PROJECT NUMBER: SP2024-013
PROJECT NAME: Site Plan for 1780 Airport Road
SITE ADDRESS/LOCATIONS: 1780 AIRPORT RD, ROCKWALL, TX 75087

CASE CAPTION: Discuss and consider a request by Jeff Carroll of Jeff Carroll Architects, Inc. on behalf of Margie Verhagen of Meals on Wheels for the approval of a Site Plan for a facility for a Social Service Provider (i.e. Meals on Wheels) on an 6.211-acre tract of land identified as Tract 2 of the D. Harr Survey, Abstract No. 102, City of Rockwall, Rockwall County, Texas, zoned Light Industrial (LI) District, situated within the Airport Overlay (AP-OV) District, addressed as 1780 Airport Road, and take any action necessary.

03/22/2024: SP2024-013; Site Plan for 1780 Airport Road
Please address the following comments (M= Mandatory Comments; I = Informational Comments)

TO: Planning and Zoning Commission
DATE: April 30, 2024
APPLICANT: Jeff Carroll; *Jeff Carroll Architects, Inc.*
CASE NUMBER: SP2024-013; *Site Plan for 1780 Airport Road*

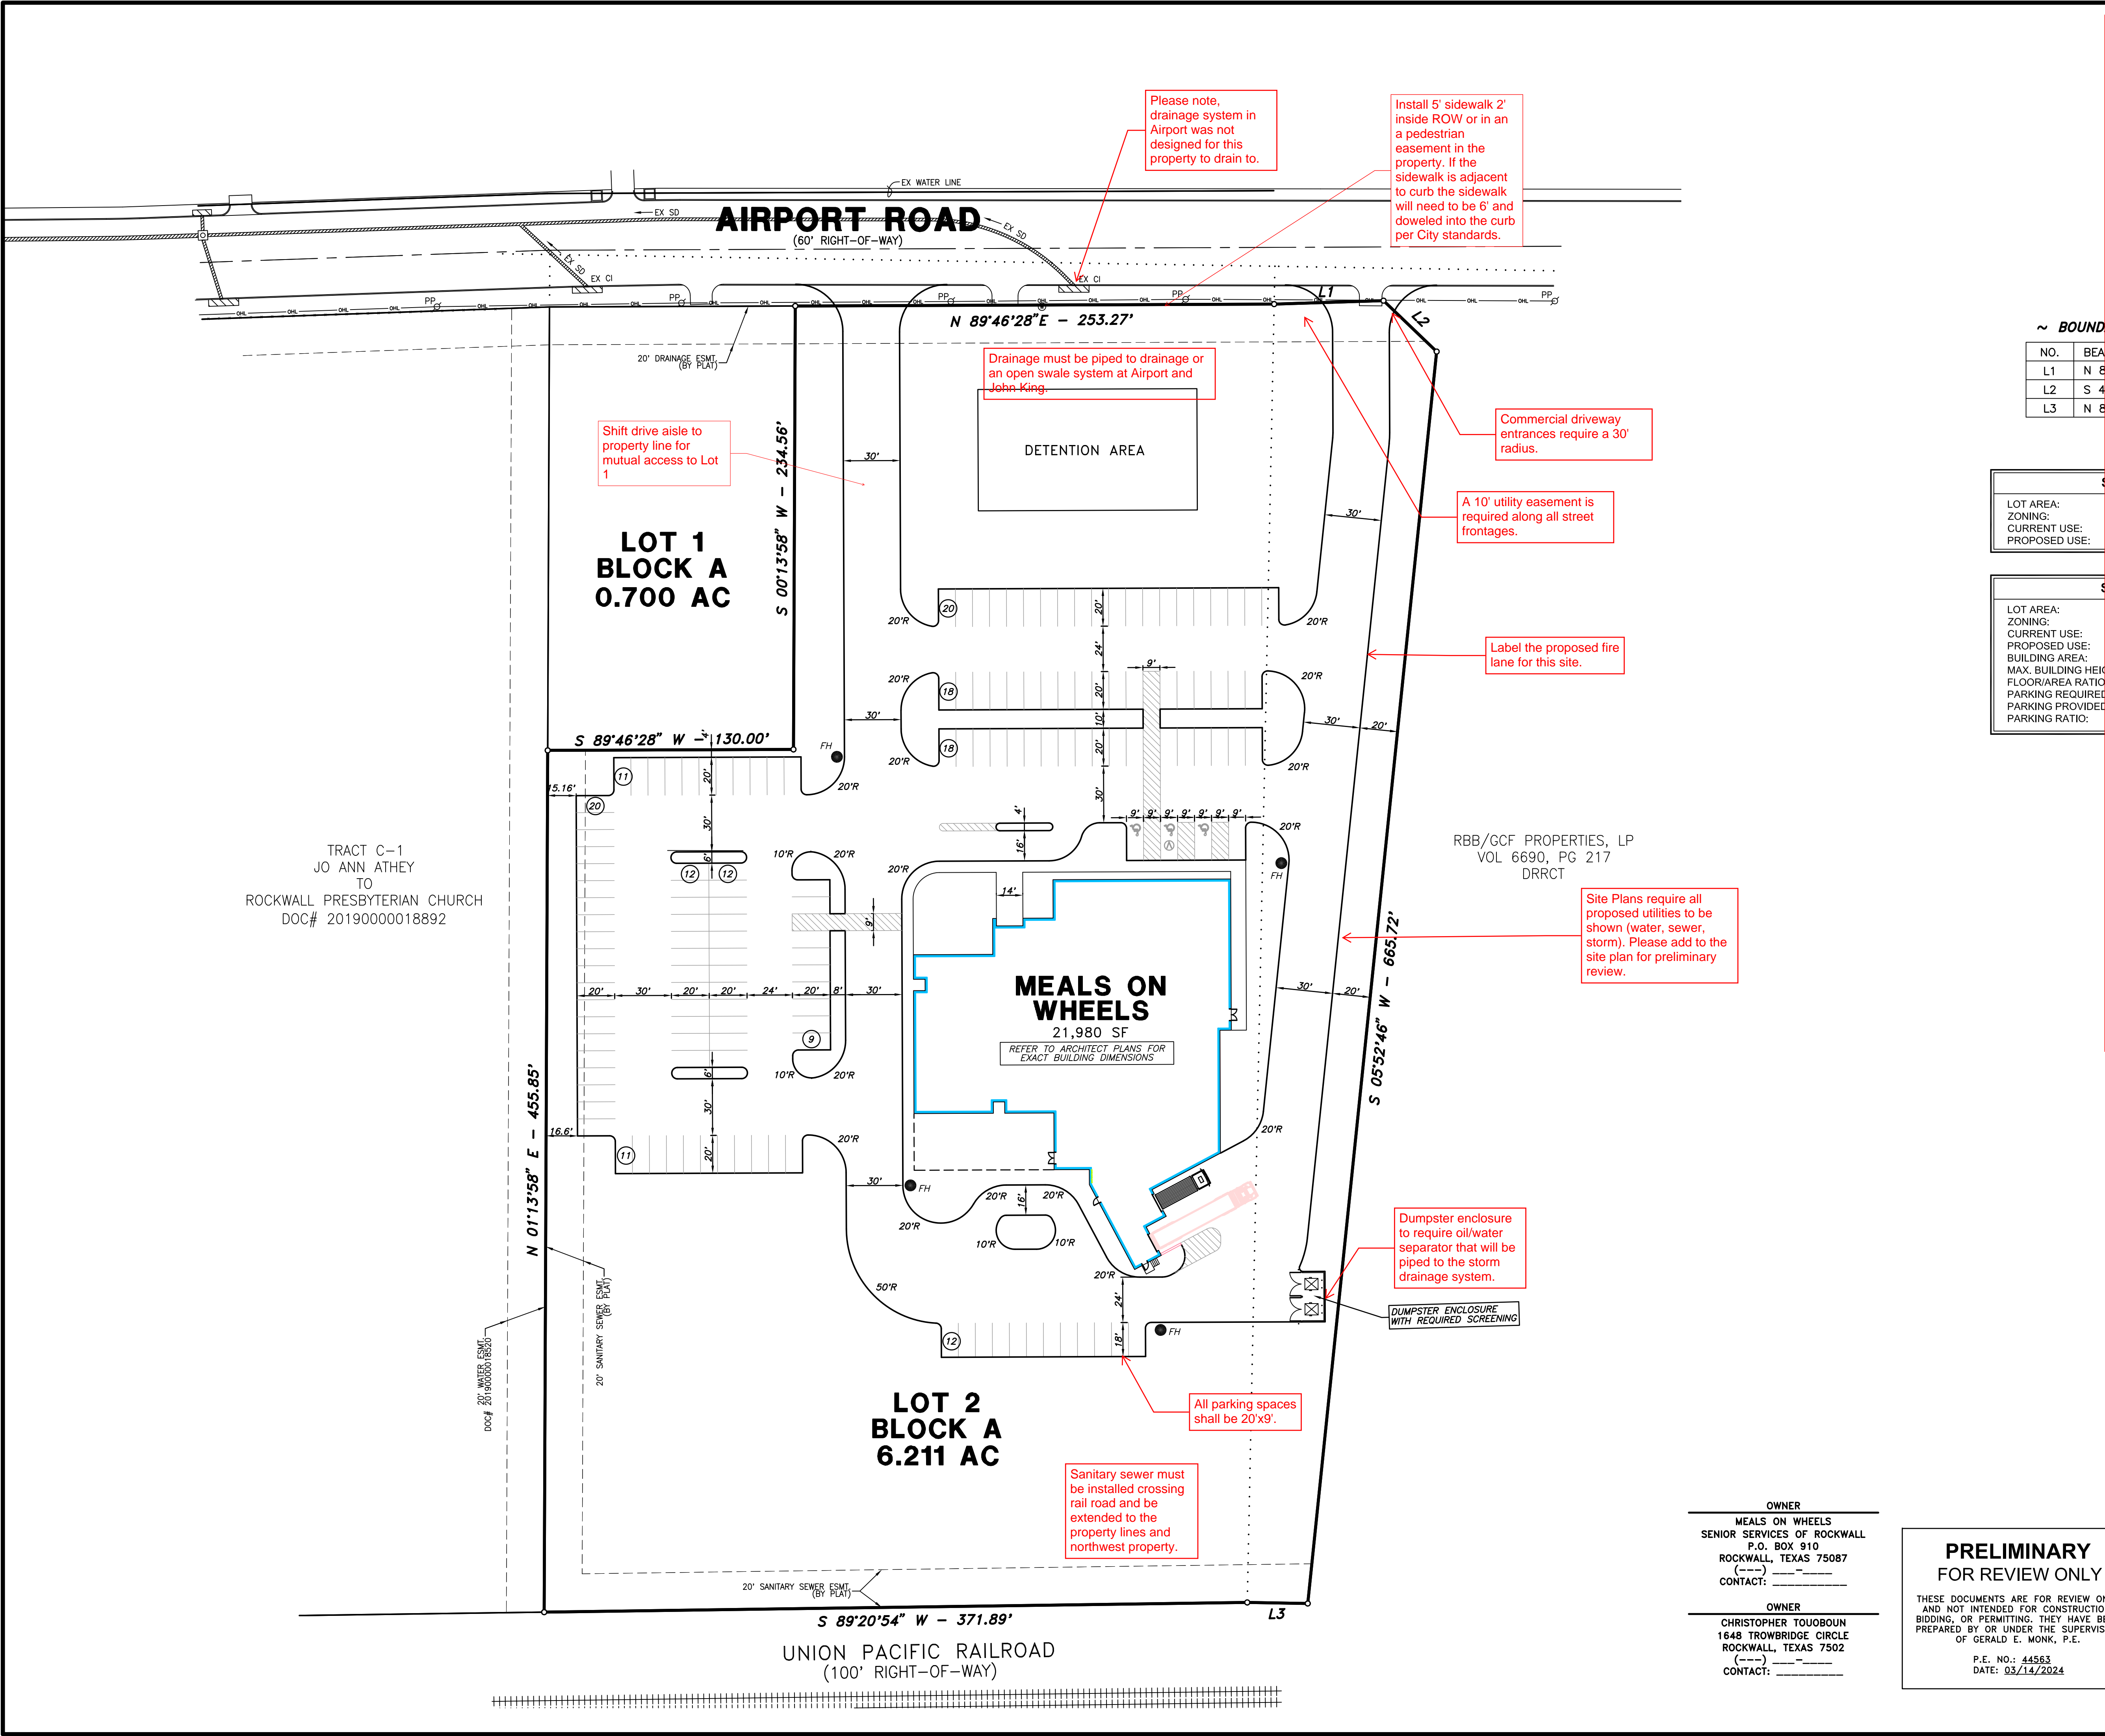
- General Items:**
- Must meet City 2023 Standards of Design and Construction
 - 4% Engineering Inspection Fees
 - Impact Fees (Water, Sewer, Roadway).
 - Minimum easement width is 20' for new easements. No structures, including walls, allowed in easements.
 - Retaining walls 3' and over must be engineered.
 - All retaining walls (18" or taller) must be rock or stone face. No smooth concrete walls.
 - No signage is allowed within easements or ROW.
 - Tree mitigation will be required for the removal of any existing trees on site.
 - No structures or fences with easements.
 - The site will need to be platted.
 - All utilities must be underground.
 - Additional comments may be provided at the time of Engineering review.
 - Need to show existing and proposed water and sewer on site plan.
